UNITED STATES
NUCLEAR REGULATORY COMMISSION
WASHINGTON, D. C. 20555

UNIVERSITY OF LOWELL

AMENDMENT TO FACILITY OPERATING LICENSE

Amendment No. 8
License No. R-125

CHART 6-1. Univ. of Lowell Administrative Structure

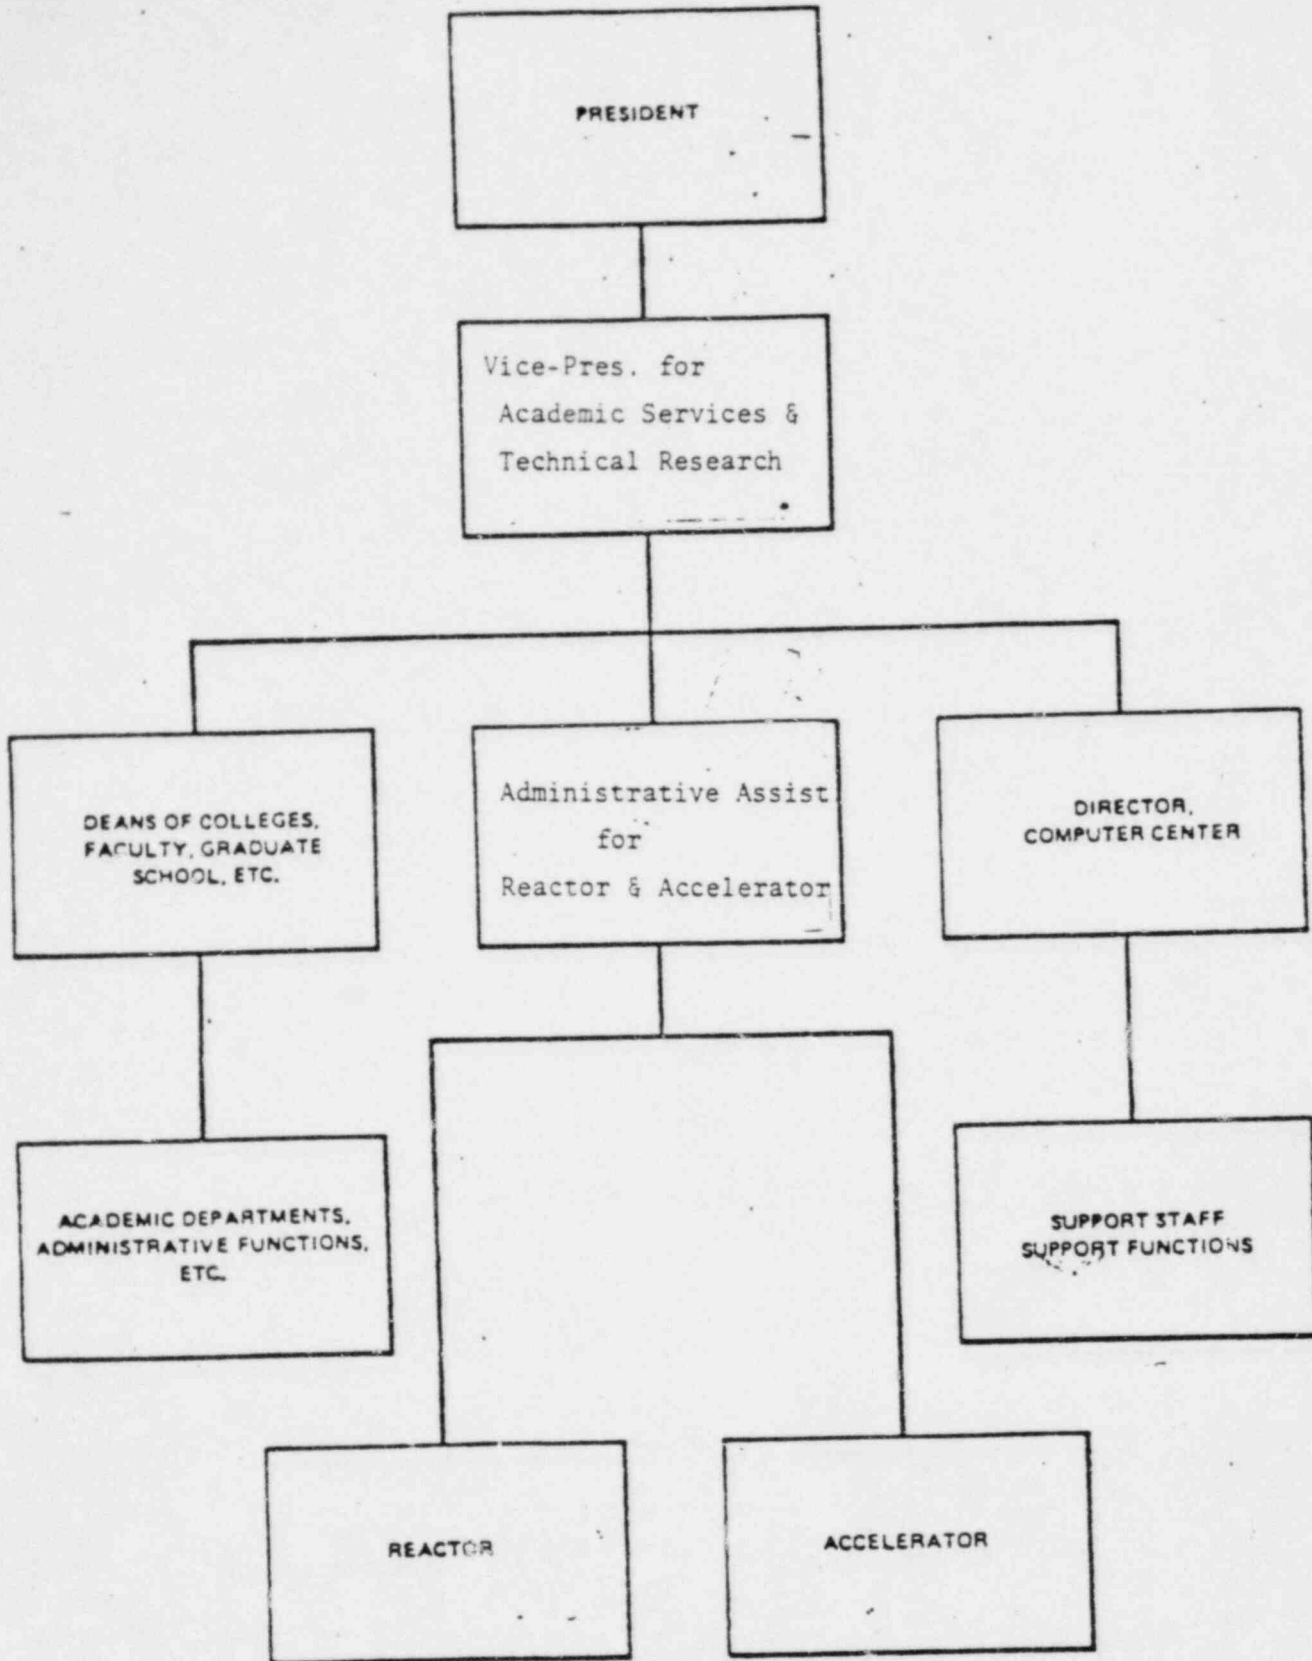
1. The reactor facility shall be an integral part of the Radiation Laboratory of the University of Lowell. The reactor shall be related to the University structure as shown in Chart 6.1 and Chart 6.2.

CHART 6-2. University of Lowell Reactor Organizational Structure

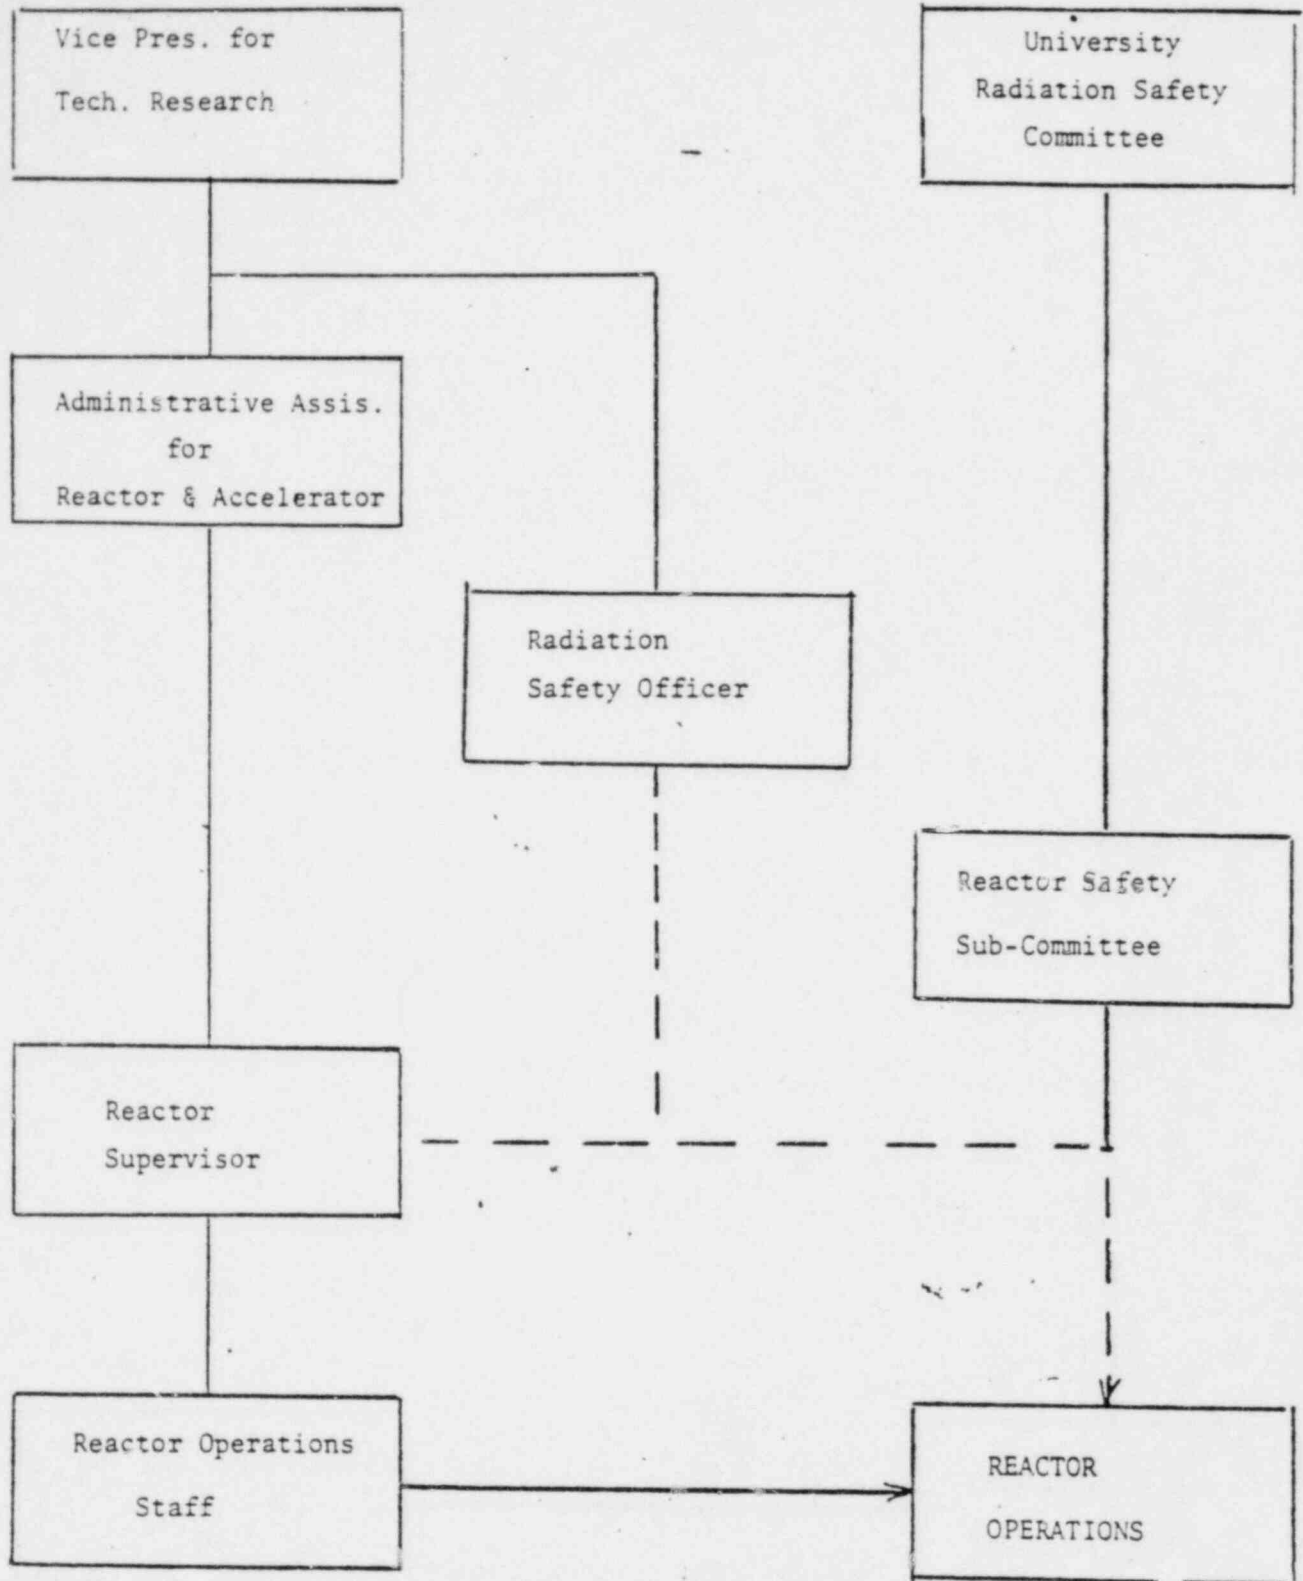
3. There shall be a Radiation Safety Officer responsible for the safety of operations from the standpoint of radiation protection. He does not report to the line organization responsible for reactor operations, but rather to the Vice President for Academic Services and Technical Research.
